ADDENDUM No. 1

March 7, 2023

BID DOCUMENTS dated 02/06/2023

CITY OF CANTON – SANITATION BUILDING PROJECT – GP 1376

B3 WINDOW JAMB DETAIL
1 1/2" = 1'-0"

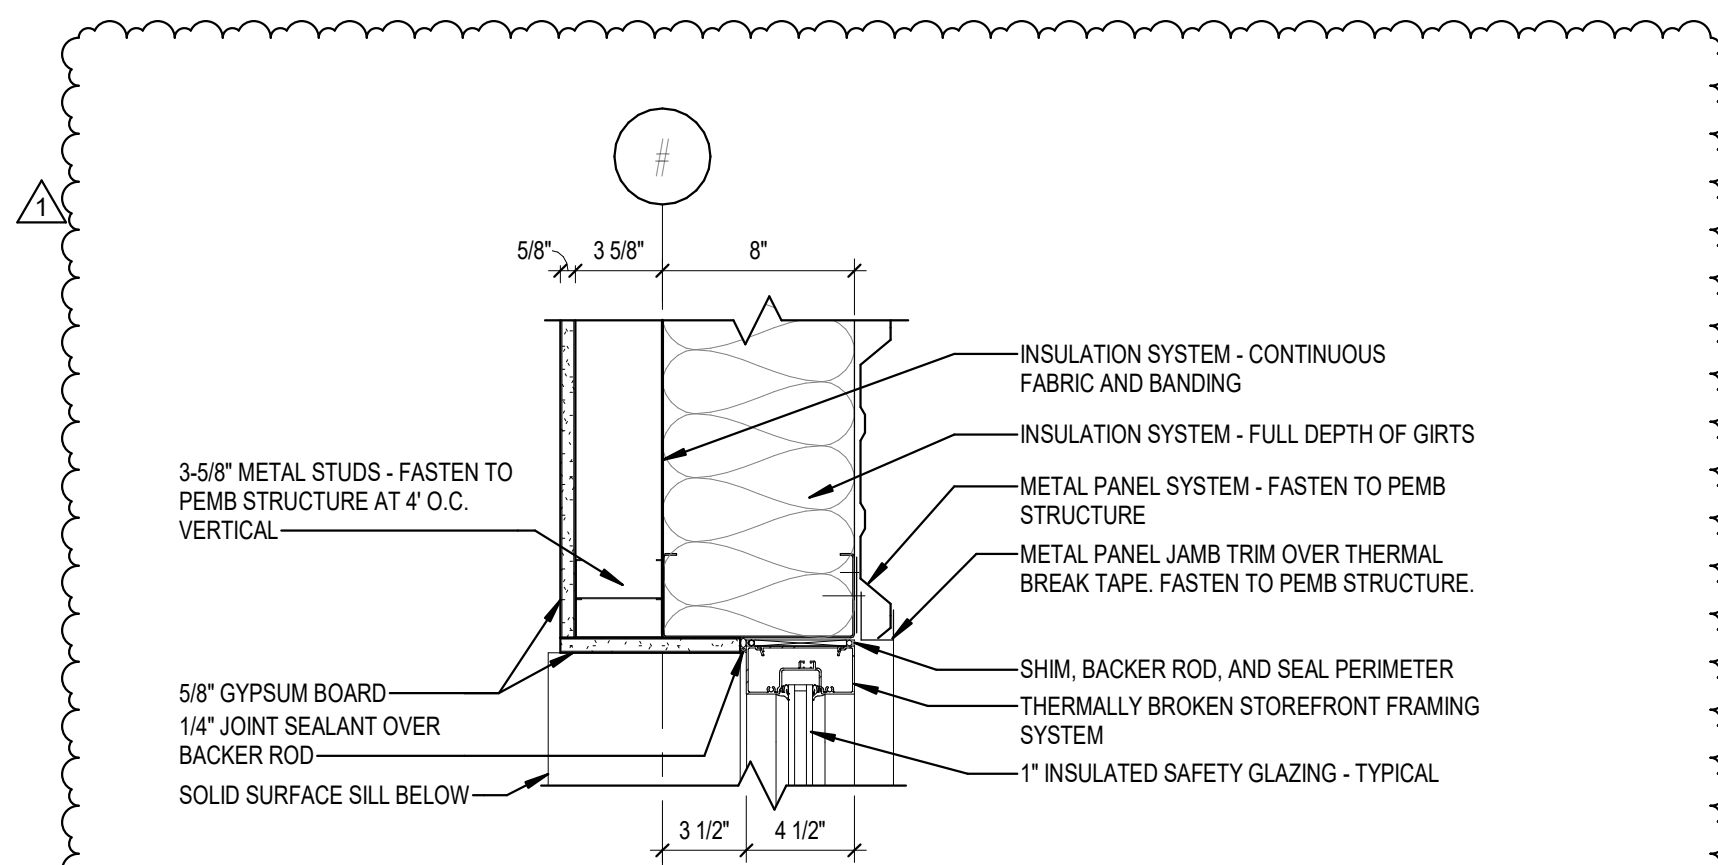
- a. Added window sill detail Drawing A3
- b. Added window jamb detail Drawing B3
- c. Modified window sill detail Drawing C1

E-102

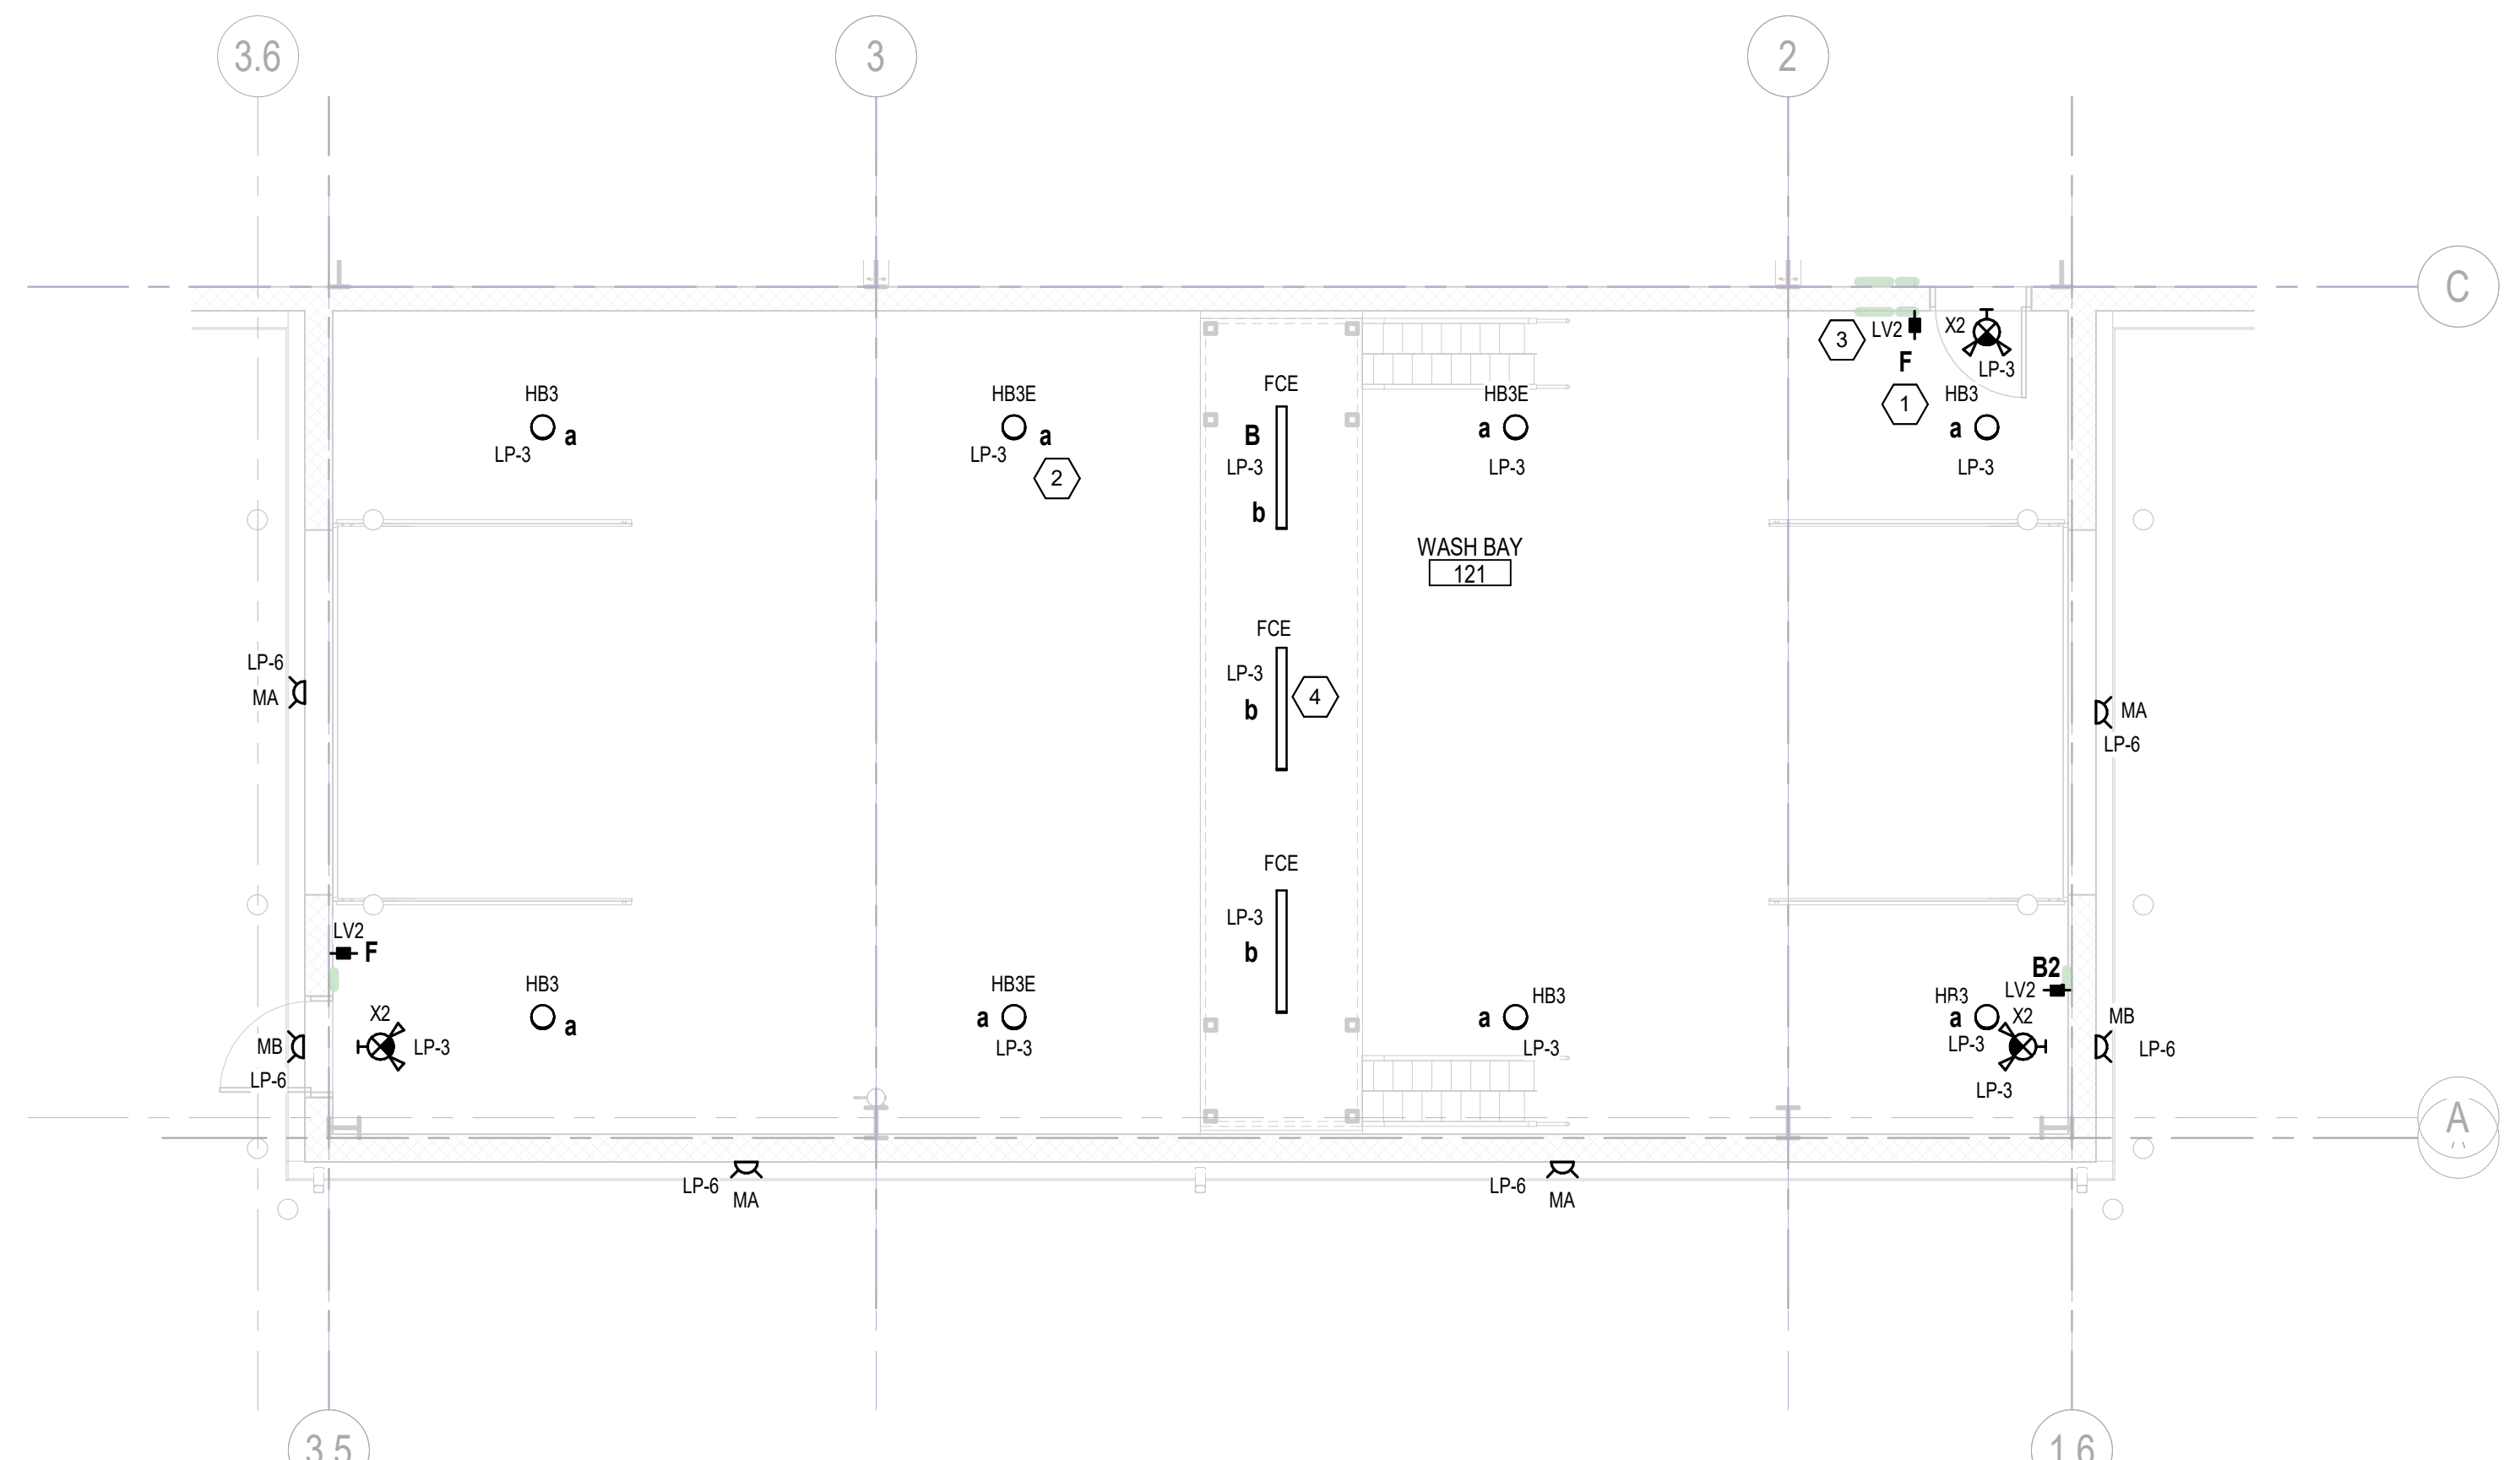
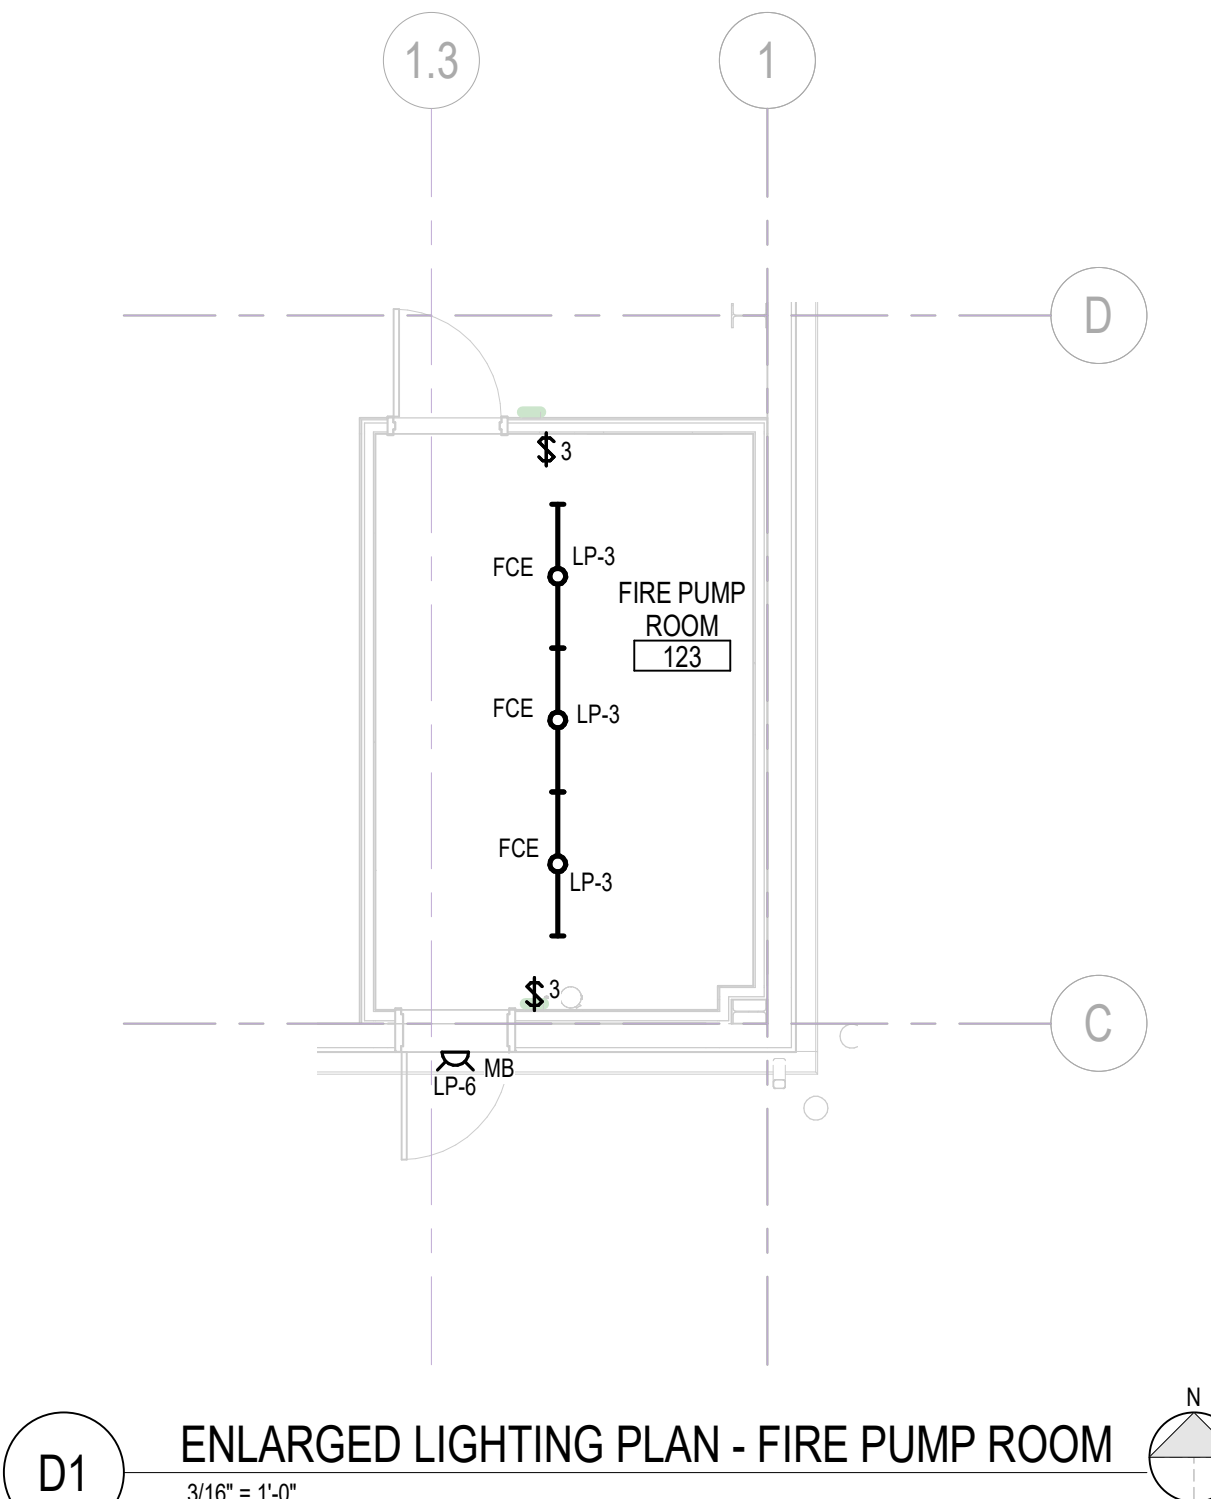
23. E-102 ENLARGED LIGHTING PLANS – OFFICE, WASH BAY, FIRE PUMP RM

- a. Added notes for receptacle control in the interior lighting control scheme.

FOUNDATION WALL OPTIONS

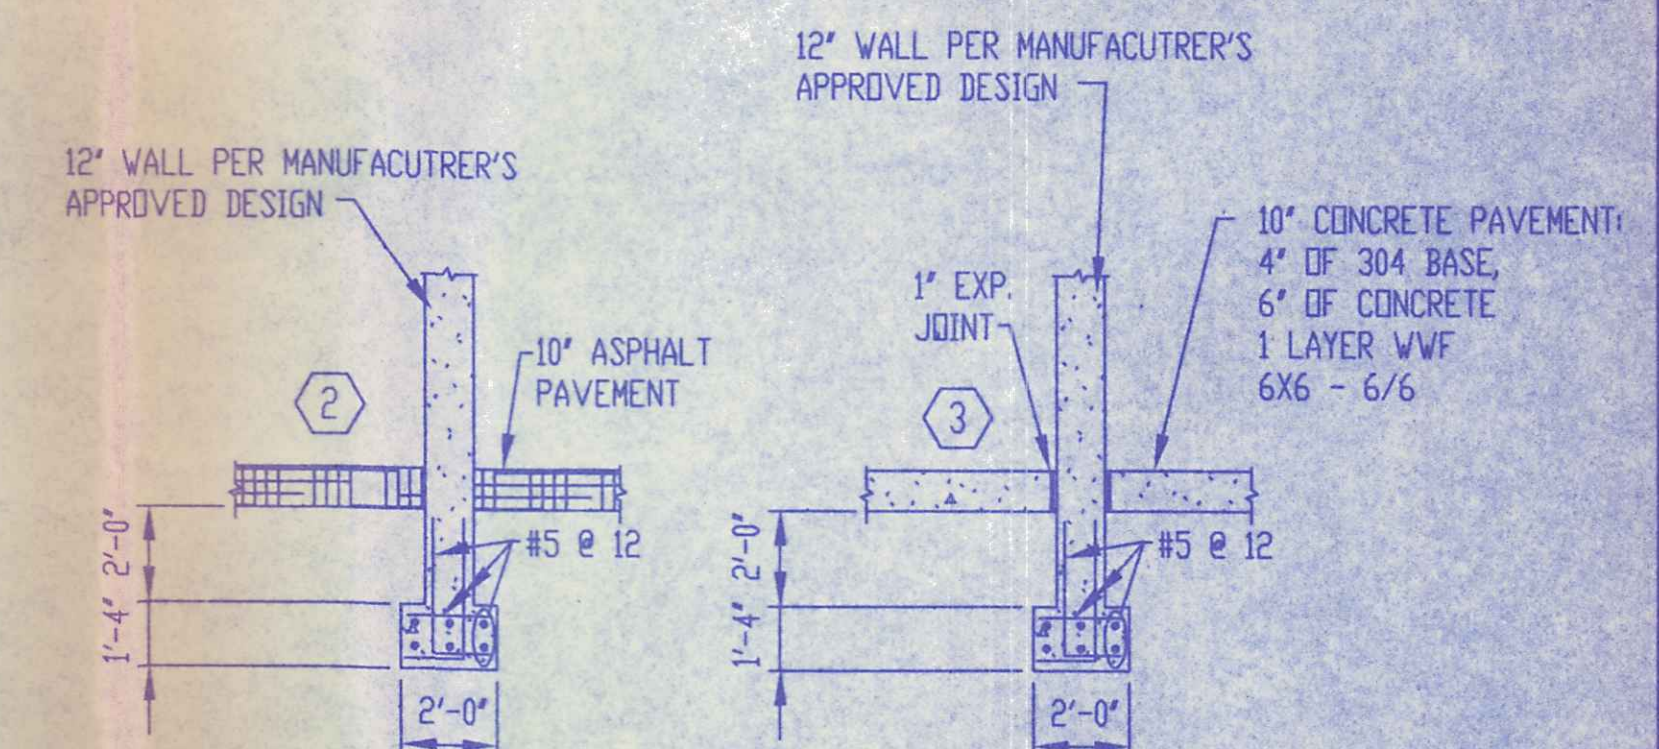
9. *Question: What is the depth of the existing salt dome foundation to be demolished?*
Response: See attached wall section of the largest salt dome showing a 3'-4" deep foundation. The other (2) salt dome foundation depths are unknown; but from a bidding standpoint assume 4'-0".
